REVIEW AND EVALUATION OF THE
GIBSON DOME HIGH LEVEL NUCLEAR WASTE
REPOSITORY ENVIRONMENTAL ASSESSMENT:
GEOHYDROLOGIC ISSUES

Christopher J. Duffy
and
Brad Hall

December 8, 1984

Figure 2.1. Potentiometric surface, Mississippian Aquifer (Figure 2 from Hanshaw and Hill).

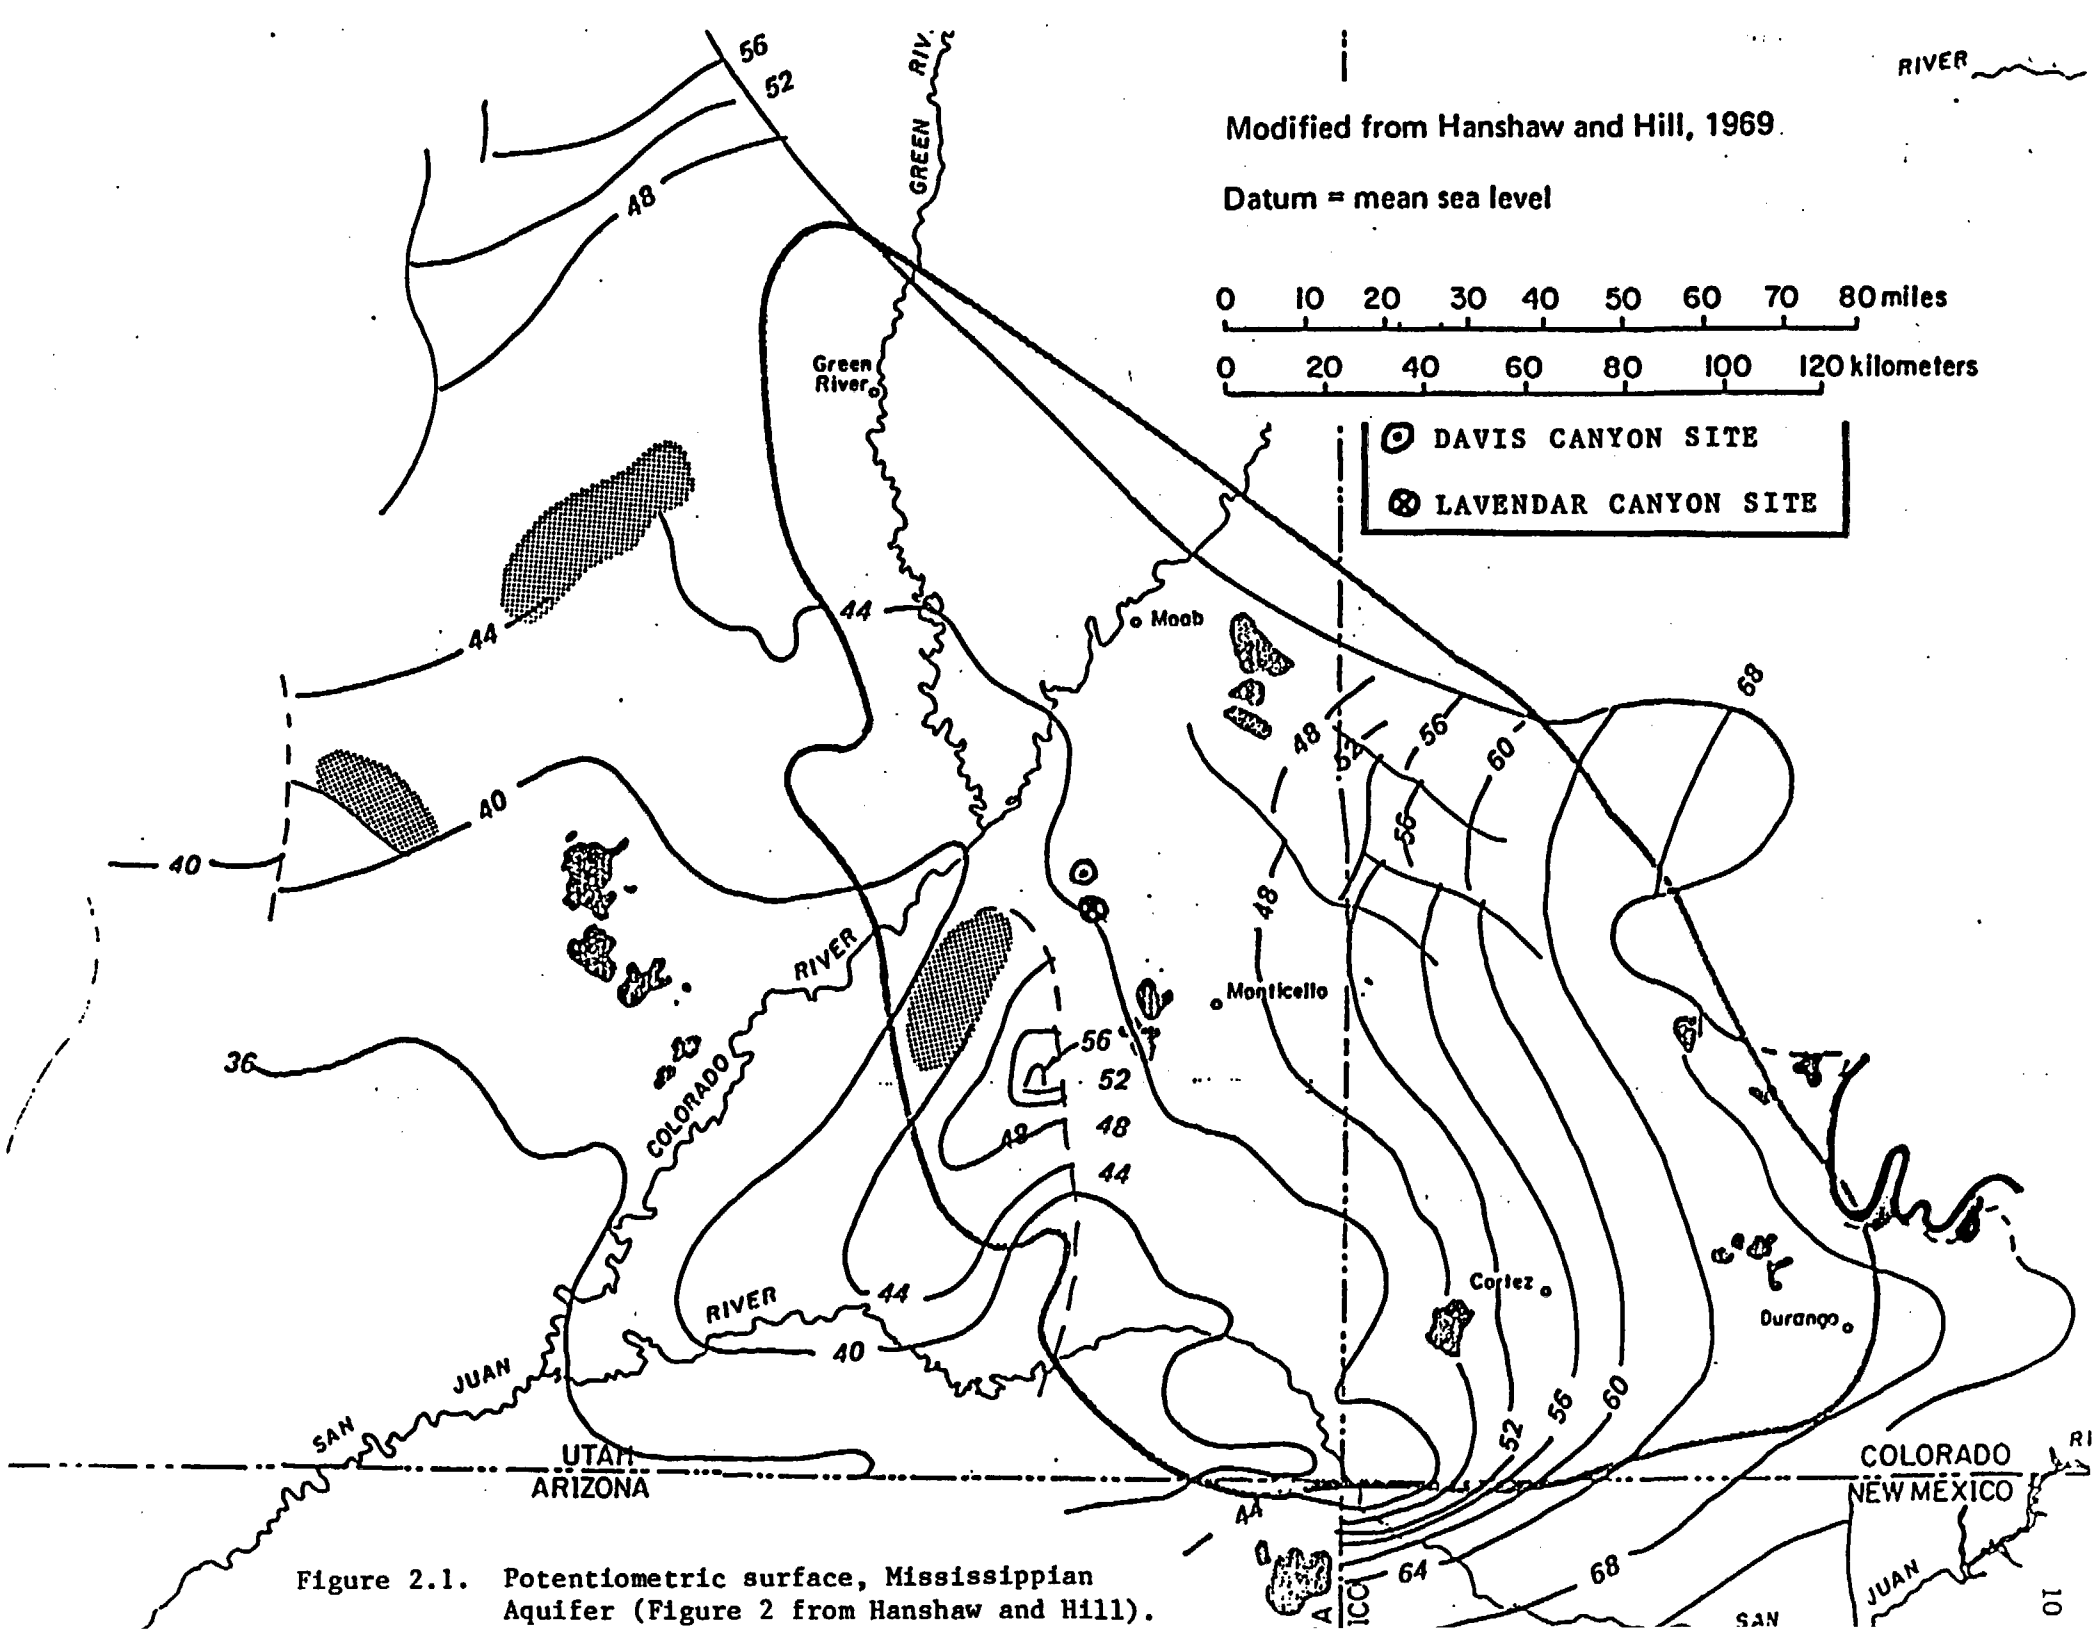
Another indication of the problem encountered when data are sparse can be observed by comparing the difference in potentiometric surface maps developed for the region near the repository. Figure 2.1, after Hanshaw and Hill (1969), shows that the repository is located on or near a ridge of the 4400 foot contour line. Figure 2.2 from both the Lavender and Davis Canyon Environmental Assessments shows the repository on a relatively straight section of the 4400 foot contour line. This demonstrates the arbitrary nature of potentiometric maps where essentially no data are available.

Figure 4-3

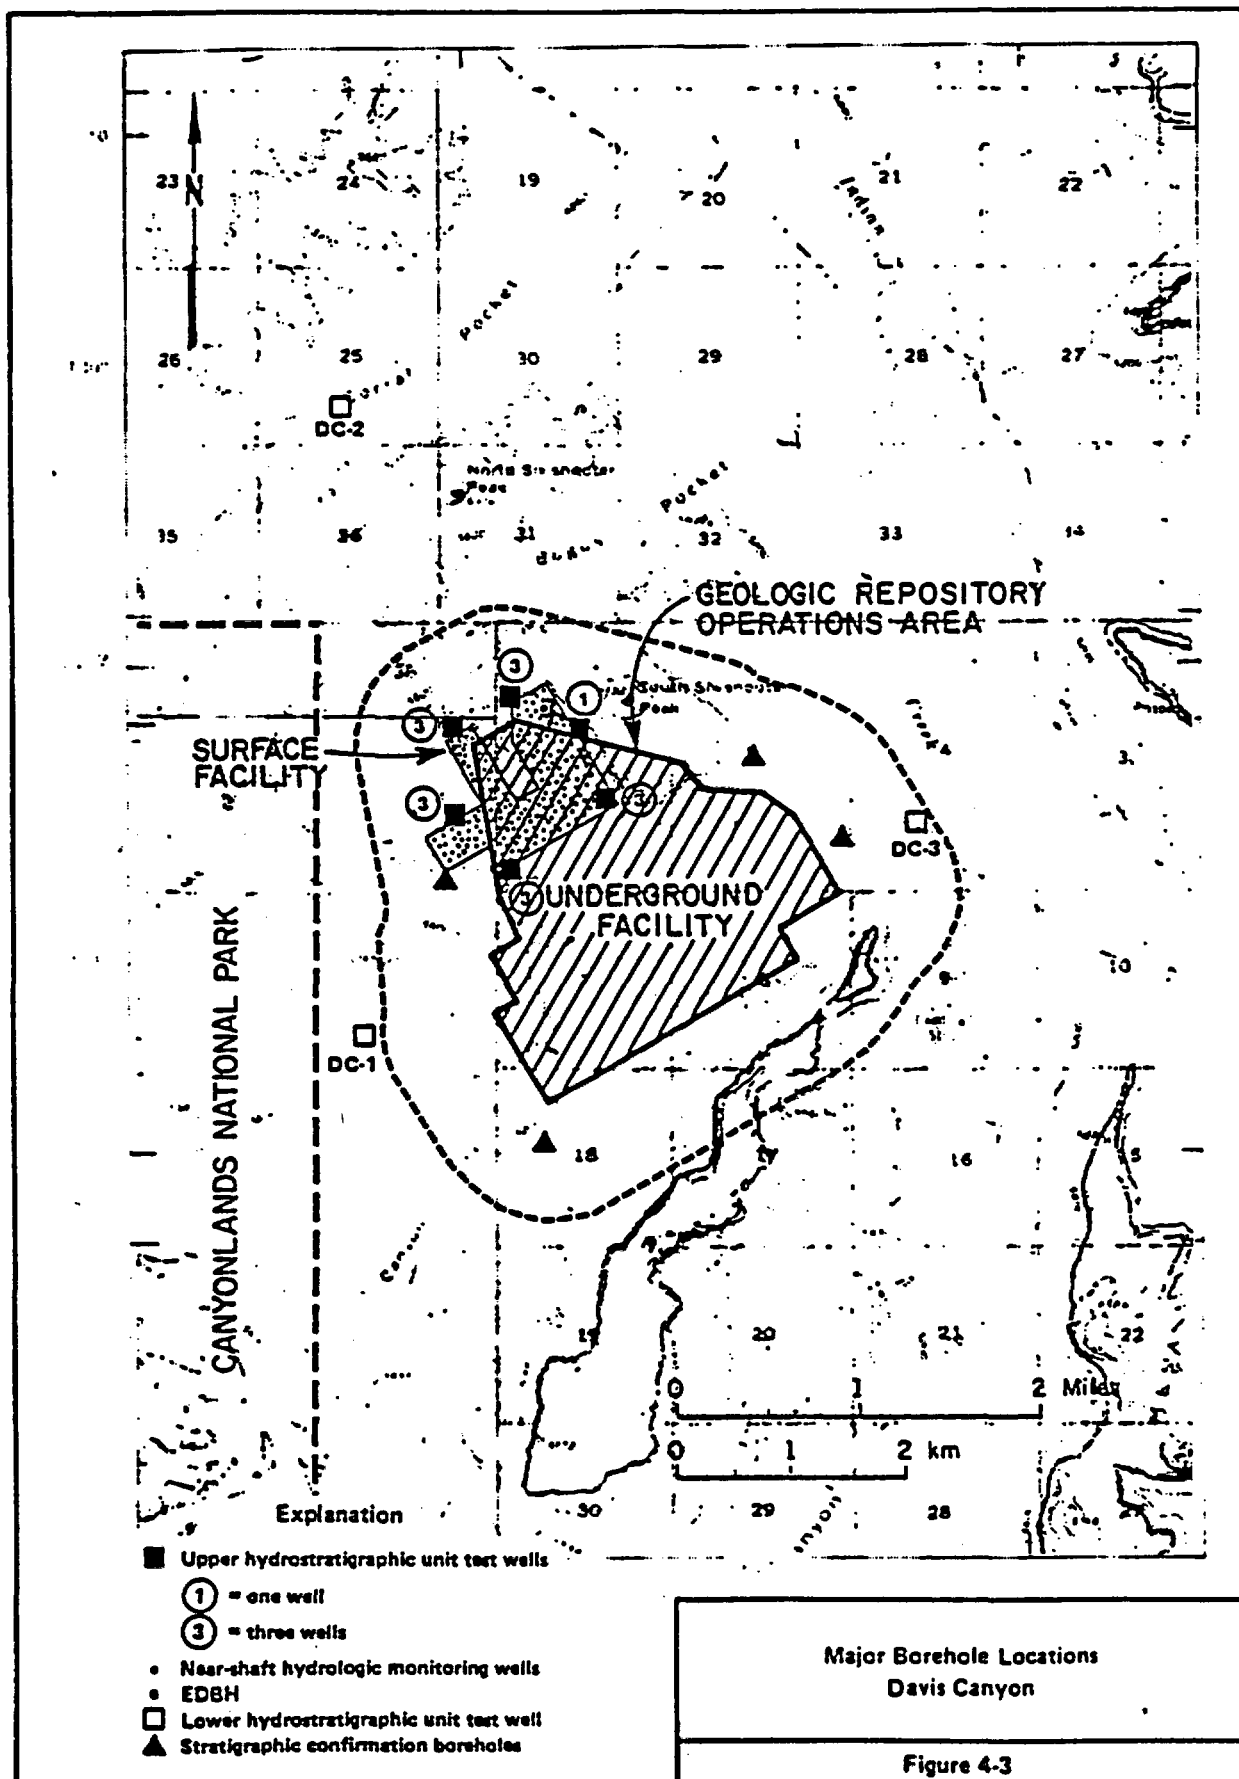
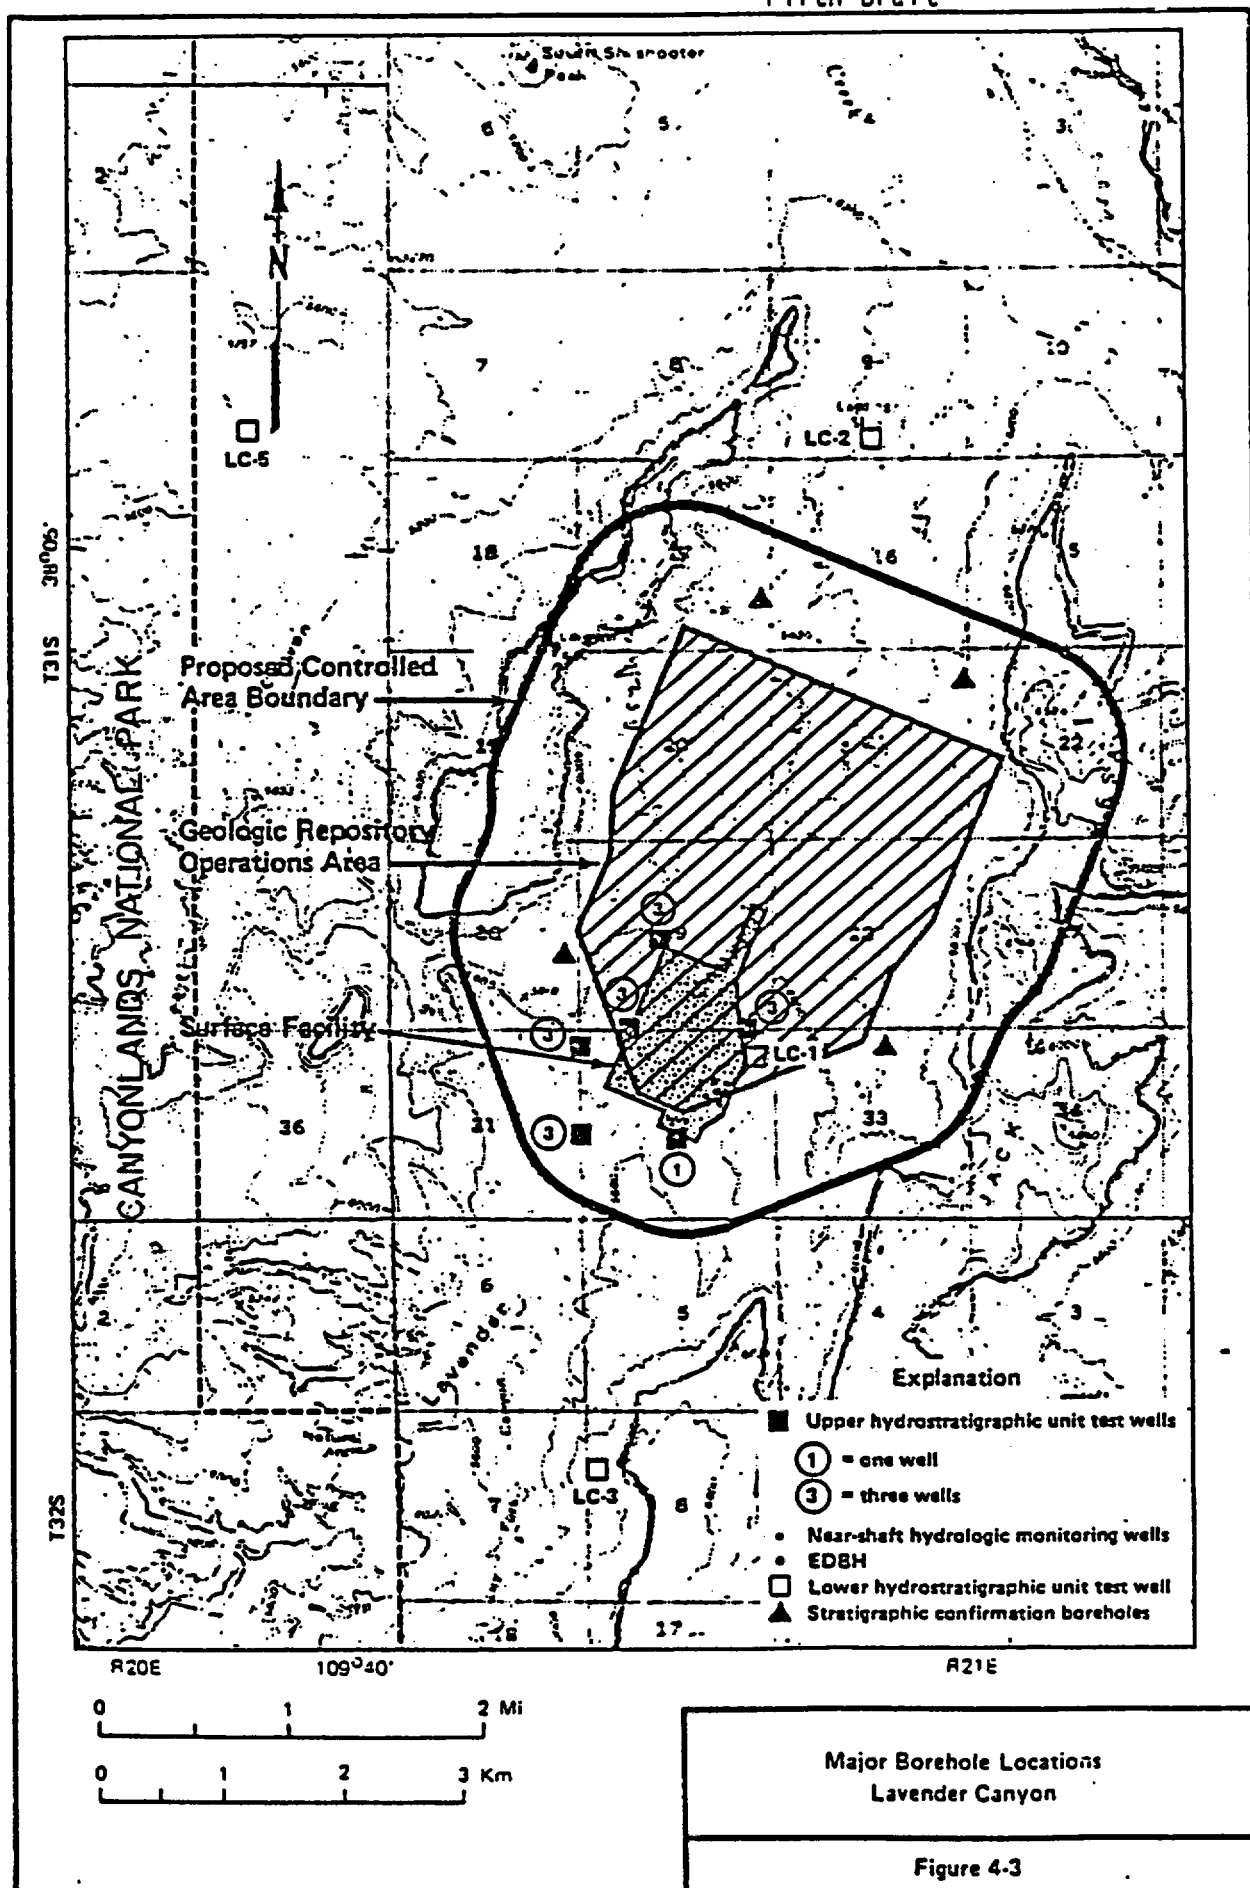
- A. Only two observation wells within the lower hydrostratigraphic unit are proposed to the west of the underground facility, which is clearly inadequate given the expected uncertainties in flow direction.

- B. Shaft seal leaks or vertical flows into the upper hydrostratigraphic unit would be expected to move to the north or northwest from the repository. The upper hydrostratigraphic unit test wells are clustered more to the south and west of the Engineering Design Borehole. Thus the majority of the proposed monitoring wells are not along expected flowpaths.
